# Space Analysis & Program Review/Mechanical Review

01 GROUND FLOOR PLAN

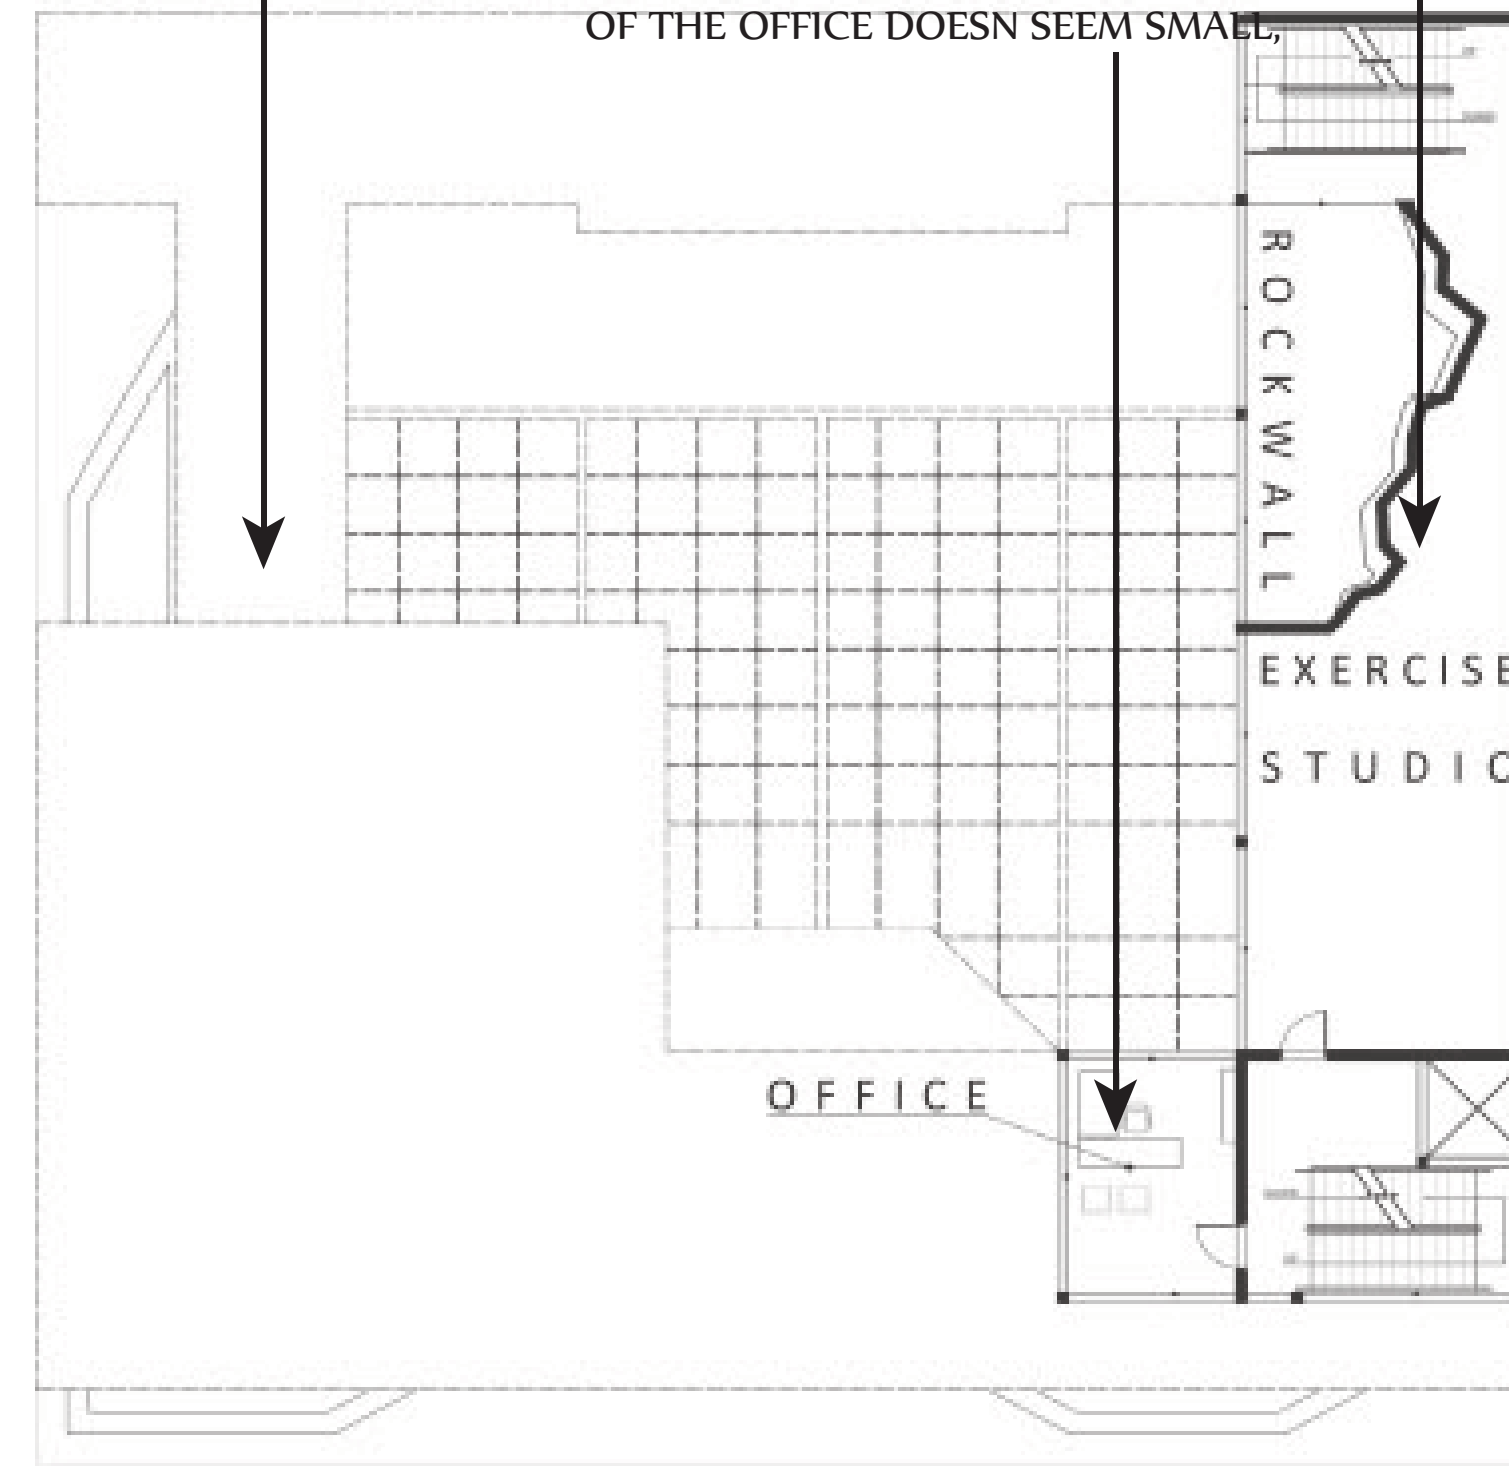
FROM THE CAFE, IS THE KITCHEN WHICH HAPPENS TO BE SMALL, BUT ALSO A PATH INTO THE GARDEN THAT LEADS INTO THE ROCKWALL

FROM THE LOBBY, IS WHERE THE POOL IS LOCATED, CONNECT TO THE GARDEN, AND THE CAFE

WITH THE LOBBY, WHICH IS CONNECTED TO THE STUDIO, BUT ALSO LEAD BY THE LOBBY, WHICH IS LEAD WITH A CORRIDOR THAT CONNECTS TO THE CAFE,

02 2nd FLOOR PLAN

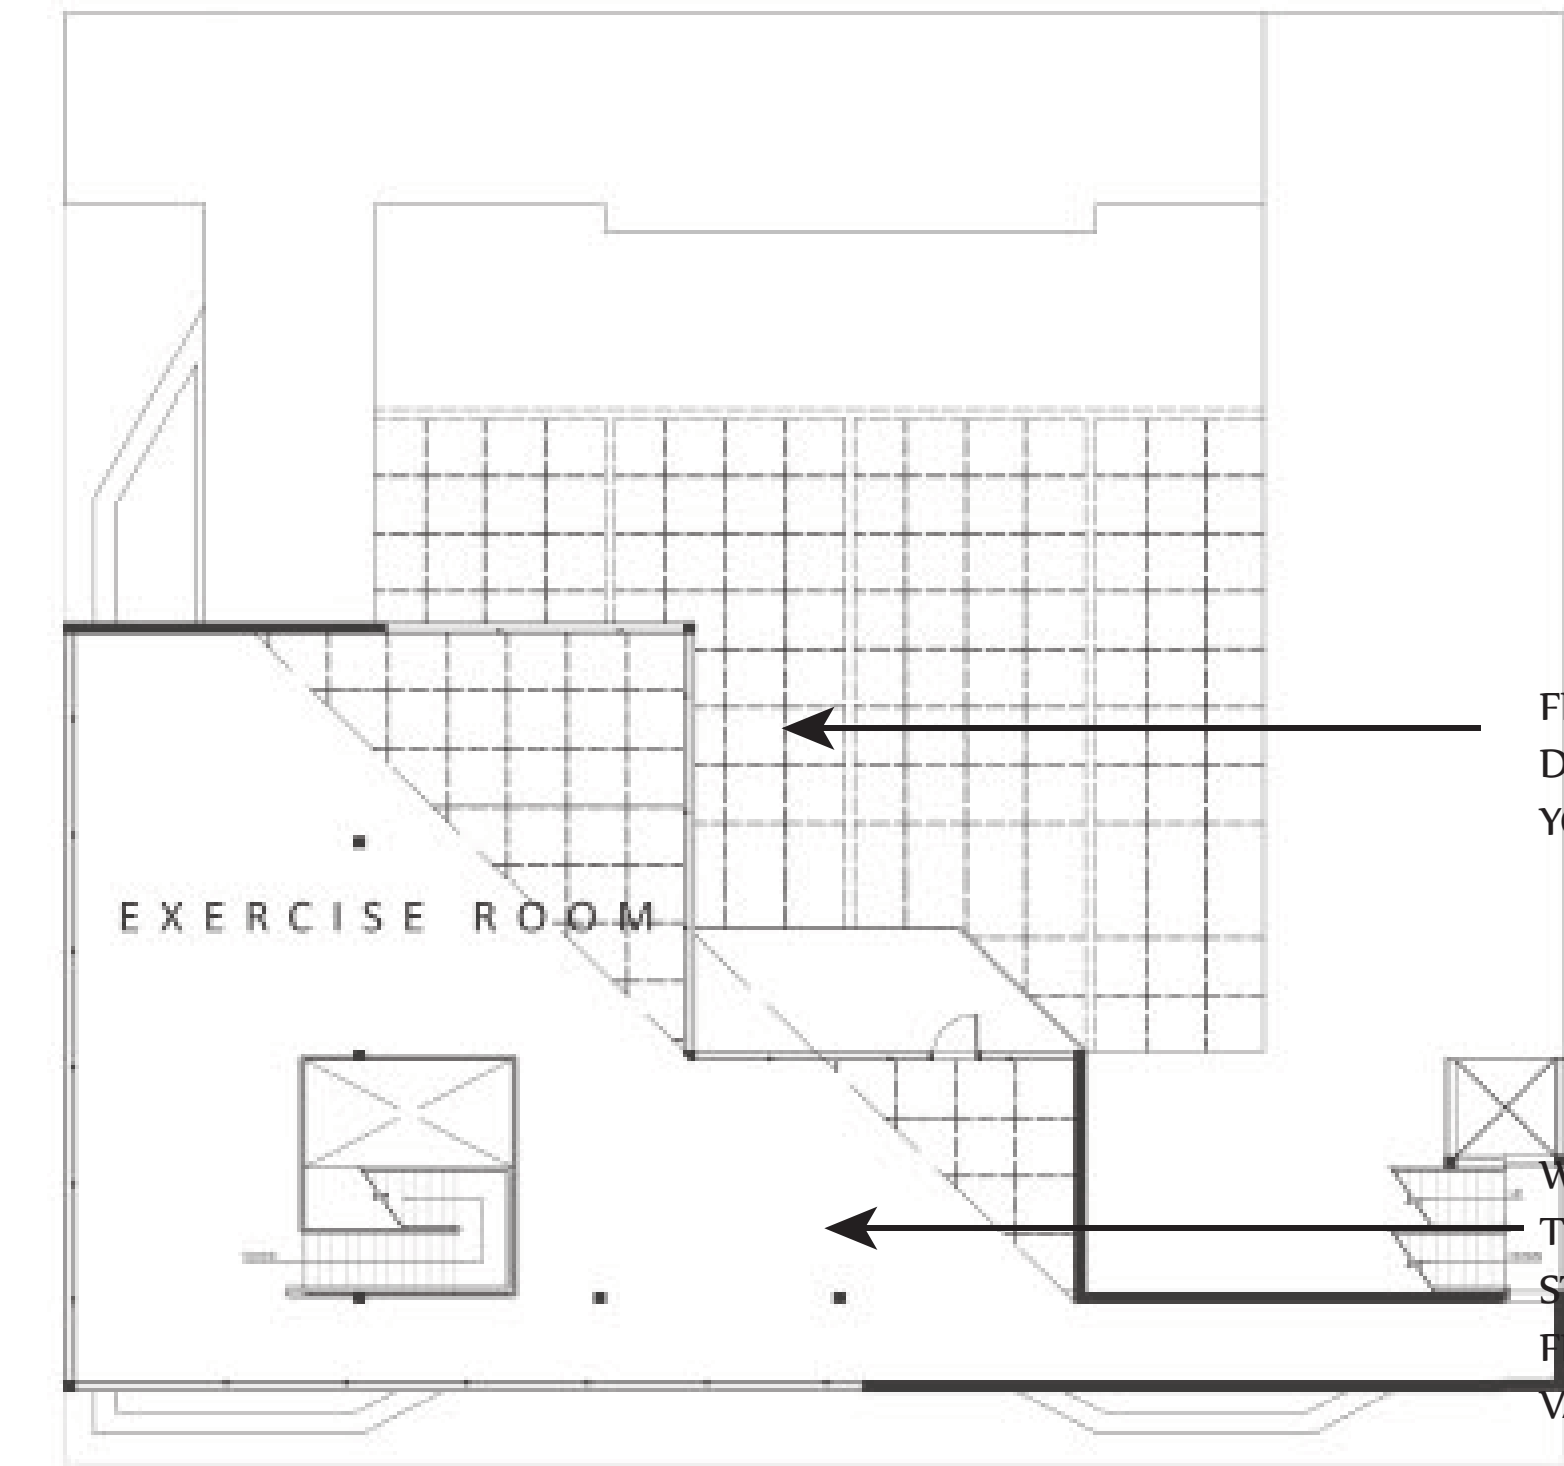
THE HEALTH CLUB DESIGNED TO WHERE THERE IS DOUBLE HEIGHT SPACE, ABOVE THE FIRST FLOOR POOL, THERE IS NO EXISTING PROGRAMS

THE OFFICE IS NEAR THE STAIRCASE, AND ELEVATOR, BUT HOWEVER THE SIZE OF THE OFFICE DOESN SEEM SMALL,

THE ROCKWALL CONTINUING TO THE SECOND LEVEL, THE EXERCISE STUDIO IN LOCATED BETWEEN THE TWO STAIRWELLS, HOWEVER TO THE TOP STAIR THE CORRIDOR DOES SEEM NARROW,

06 LOCKER ROOM PLAN

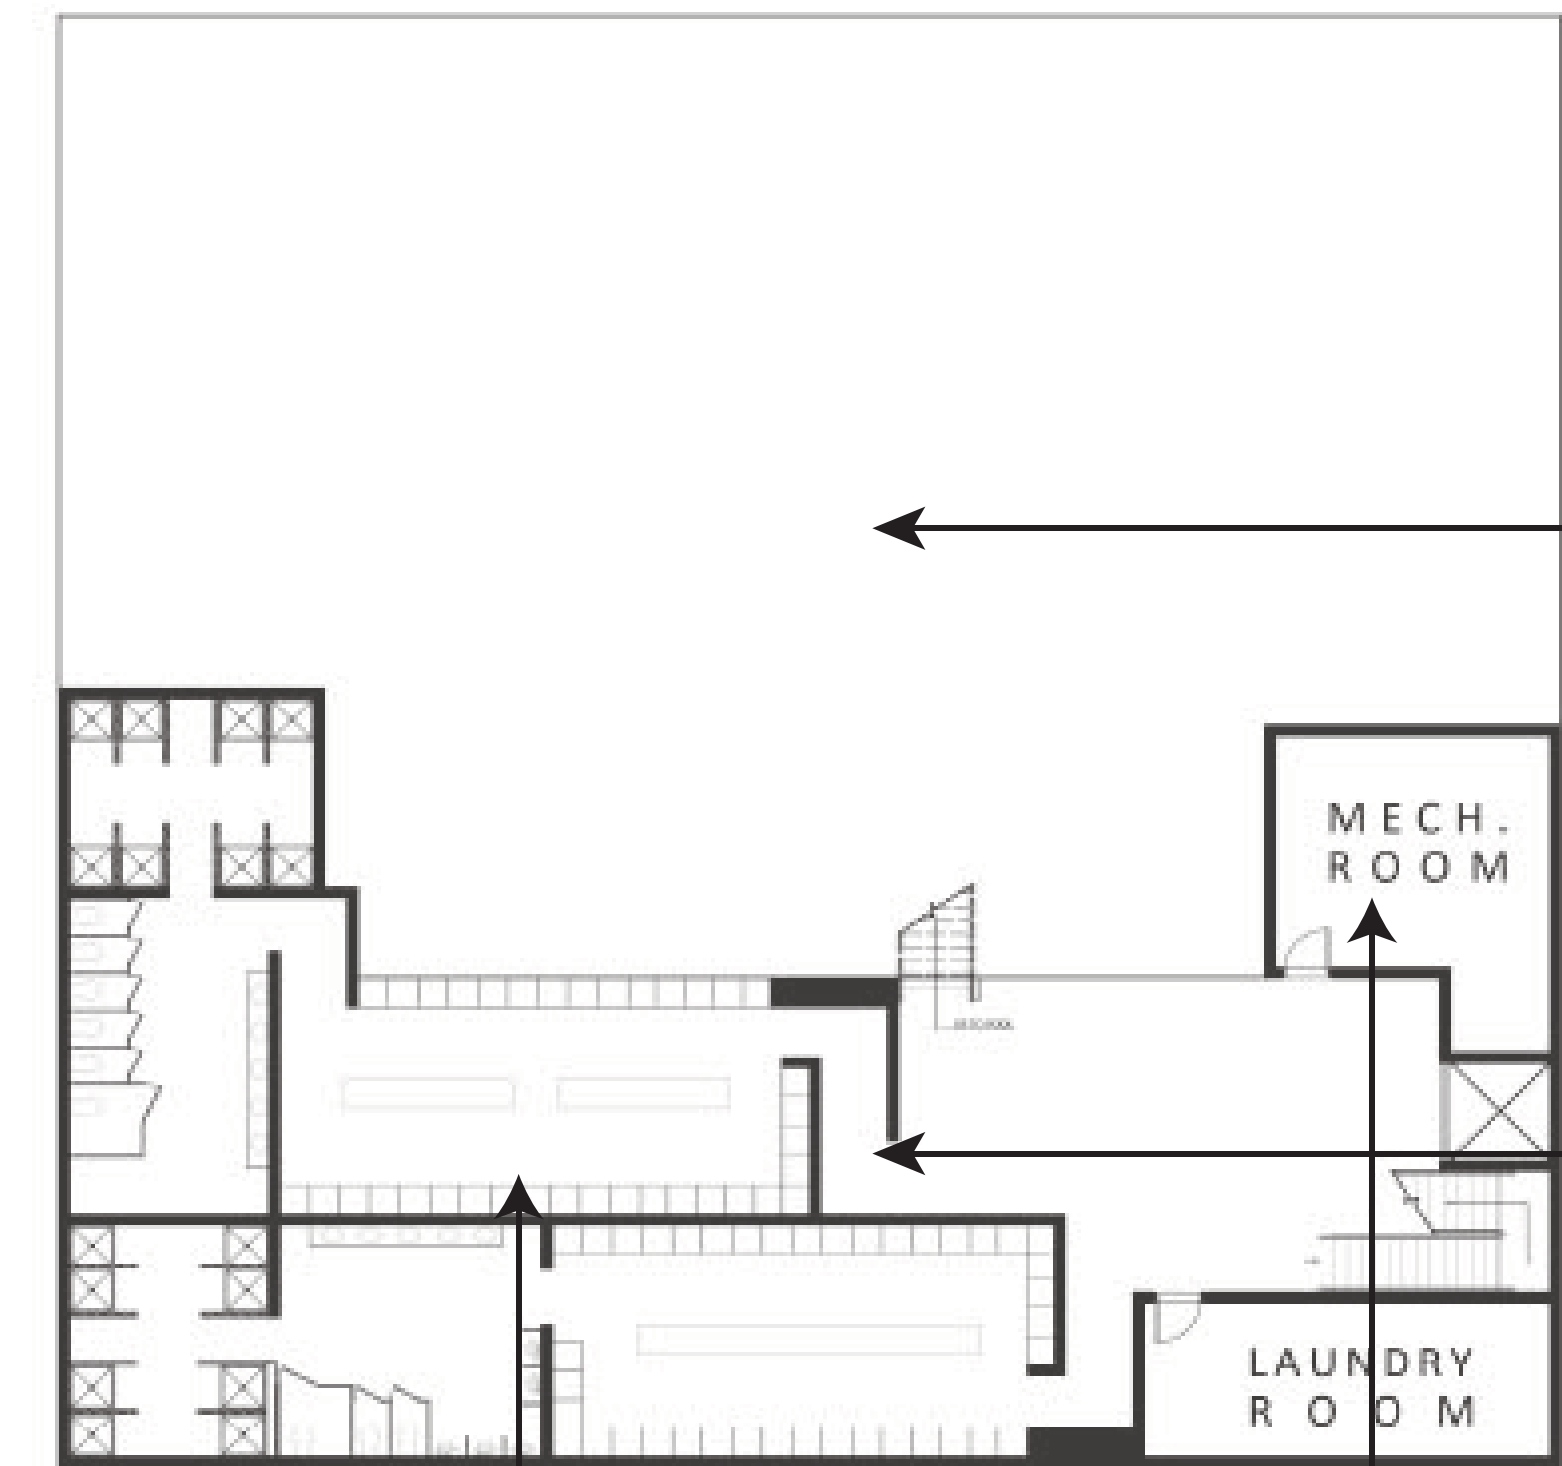
THE LOCKER ROOM HAS MIN. EXIT POINTS TO GET OUT,

THE MECH. ROOM IS VERY SMALL TO ACCOMIDATE THE BUILDING OF THAT SIZE, ALSO WITH THE POOL THERE SHOULD BE A FILER ROOM PRESENT,

THE POOL BEING RIGHT ABOVE THE LOCKER ROOM, THE POOL ISNT INCIATED ON THE PLAN,

THE LOCKER ROOM, HAS VERY SMALL CORRIDOR LEADING IN AND OUT THE ROOM,
